MISSISSIPPI POWER & LIGHT COMPANY

SUBJECT: Grand Gulf Nuclear Station
Units 1 and 2
Docket No. 50-416 and 50-417
File 0260/L334.0/L350.0
Response to SER Items
1.10(22), 1.11(17), and
1.9(8)
AECM-81/410

281.9 Provide information that satisfies the attached proposed license
(TMI conditions for post-accident sampling.
II.B.3)

Figure 281.9-1

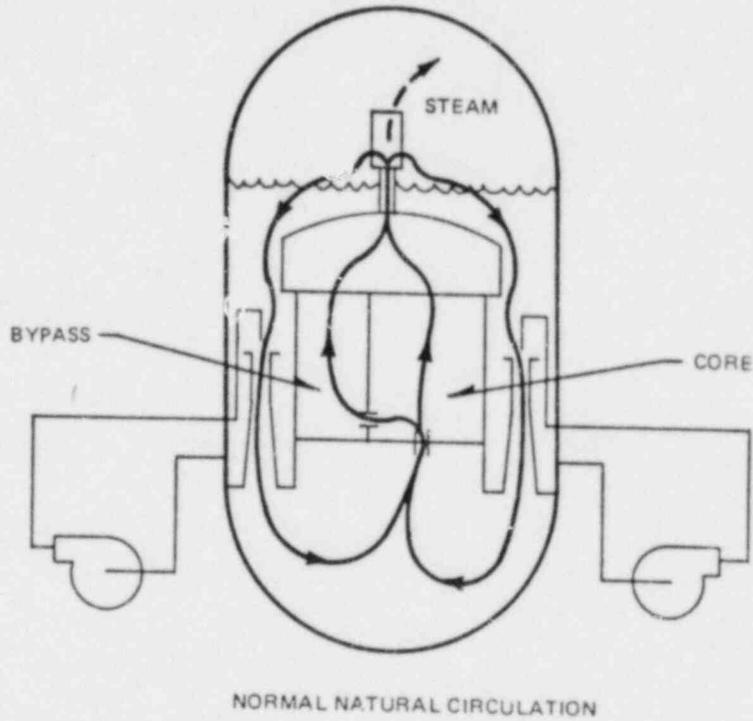
10. Demonstrate that the reactor coolant system and suppression chamber sample locations are representative of core conditions.

7. Demonstrate that the reactor coolant system and suppression chamber sample locations are representative of core conditions.

A representative core sample is directly dependent on the amount of mixing of the reactor coolant from the core region with that of the sample location. Obtaining a sample of reactor coolant that is representative of core conditions is achieved normally by sampling from the recirculation system via the recirculation loop B sample point as listed in Table 9.3-1. Therefore, adequate mixing is accomplished by forced circulation provided by the recirculation pumps. However, core flow circulation in the BWR is inherent without the use of recirculation pumps. Lack of communication between the downcomer and the core could result in disruption of the major natural circulation flow. This situation is not likely to occur in jet pump plants because of the open communication between the regions. In cases where the recirculation pumps are not available, naturally induced coolant flow is established or can be maintained by the density difference between the downcomer region and the core provided such density difference head is sufficient to balance the losses in the loop.

The primary natural circulation loop is between the downcomer and the core (See Figure 281.9-1). Due to boiling in the core region, a large difference in densities is available for driving natural circulation flow from the downcomer through the jet pumps and into the shroud region. The flow due to natural circulation is given in Figure 4.4-5.

The circulation flow of primary coolant by natural circulation is sufficient to provide mixing of the primary coolant such that a sample taken from the jet pump diffuser location would be representative of core conditions.

Obtaining a representative sample therefore is dependent upon maintaining natural circulation flow. First, for an accident such as a DBA LOCA, it is assumed that the majority of the flow of reactor coolant will be the path of least resistance and will be out of the break area eventually into the suppression pool with inventory being maintained by ECCS systems. For this worst case then, sufficient mixing would still take place in that effectively the entire suppression pool and reactor coolant become the same fluid and a sample from the suppression pool or the jet pump would be representative.

The Grand Gulf analysis indicates that the absolute minimum water level for natural circulation between the downcomer and the core region is the elevation of the jet pump suction inlet, which is 8.34 ft above the elevation of the BAF for the GGNS vessel and about 21 ft below normal water level. An analysis of small breaker accidents (SBA) with all systems operable was provided to the NRC in NEDO 24708A Revision 1, December, 1980. As can be seen from that analysis, the water level both inside and outside the core shroud did not fall below the top of the active fuel (TAF). It is assumed therefore that for a SBA, sufficient inventory is conservatively maintained such that

water level is maintained \geq 8.34 ft above the bottom of the active fuel (BAF) or at the level of the jet pump suction. For water levels higher than the jet pump suction inlet, naturally induced flow will be maintained by the density difference between the downcomer region and the core provided such density difference head is sufficient to balance the irreversible losses in the Loop. The minimum required water level can thus be higher than the jet pump inlet and will depend on the pressure in the RPV and decay heat. The latter is a function of time after scram. This level is thus determined for chosen RPV conditions by balancing the hydrostatic driving head between the downcomer and the core against the pressure drop for vanishing flow thus different RPV levels were considered with decay heat generation spanning a time period up to several days after shutdown. The minimum required downcomer water levels in order to provide natural circulation through the core are summarized below:

CORE DAMAGE GRAPH

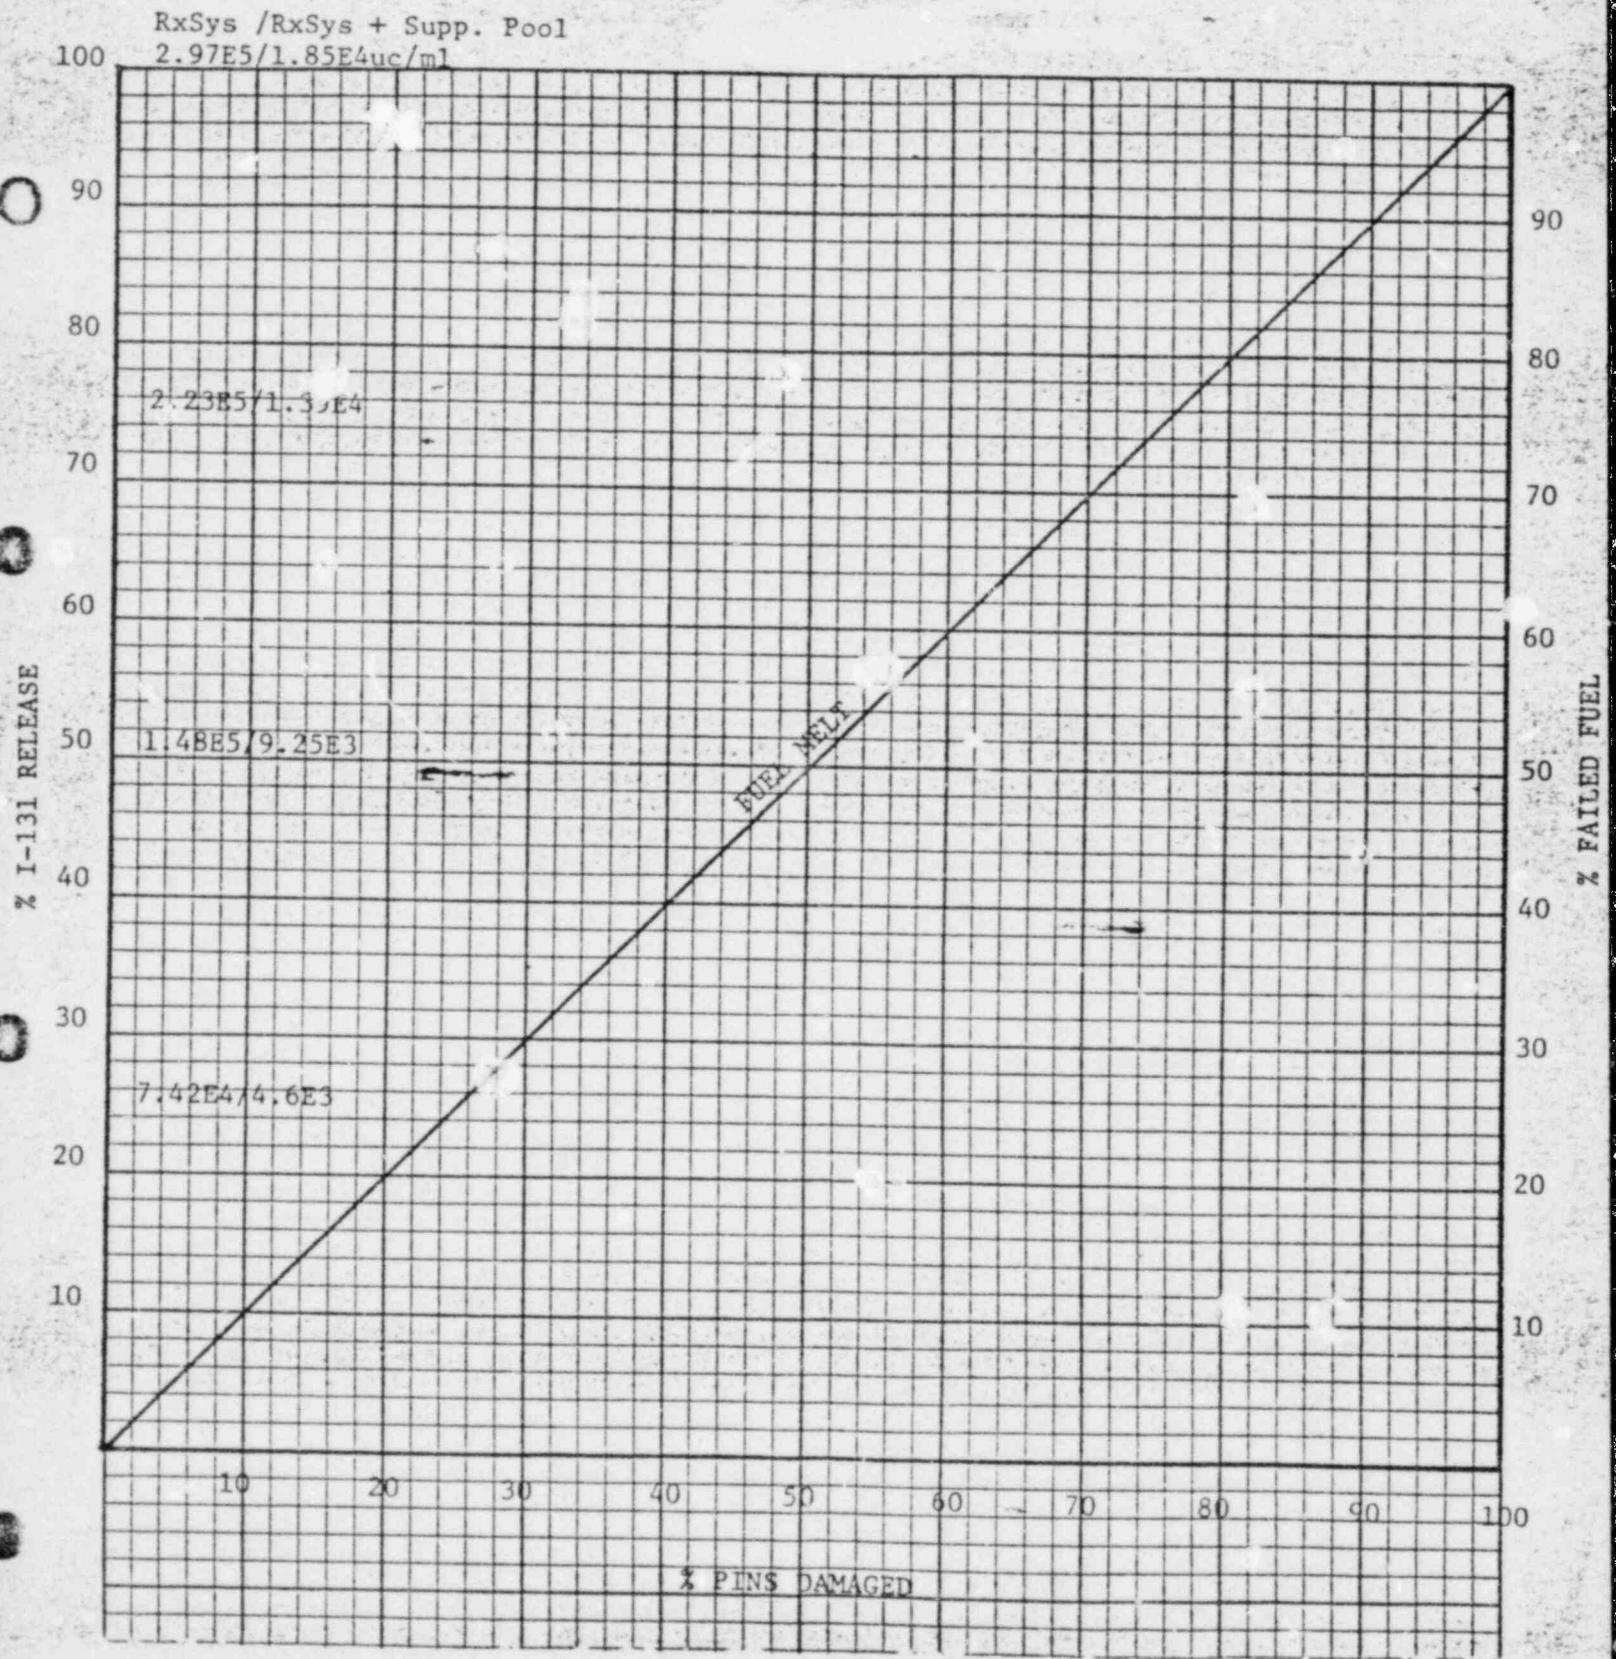
6. Provide a procedure for relating radionuclide gaseous and ionic species to estimated core damage.
7. State the design or operational provisions to prevent high pressure carrier gas from entering the reactor coolant system from on line gas analysis equipment, if it is used.

Condition 6: A method for relating radionuclide gaseous and ionic species to estimate core damage is being devised by General Electric for the fuel type being used at Grand Gulf. Completion of this package is presently scheduled for May 1982 with an interim report available August 1982. Until receipt of this package, a temporary failed fuel estimation procedure will be prepared on the basis of I-131 concentrations as identified in the McGuire Nuclear Station procedure on the same subject. A draft of this interim procedure is enclosed (attachment 4) for your review.
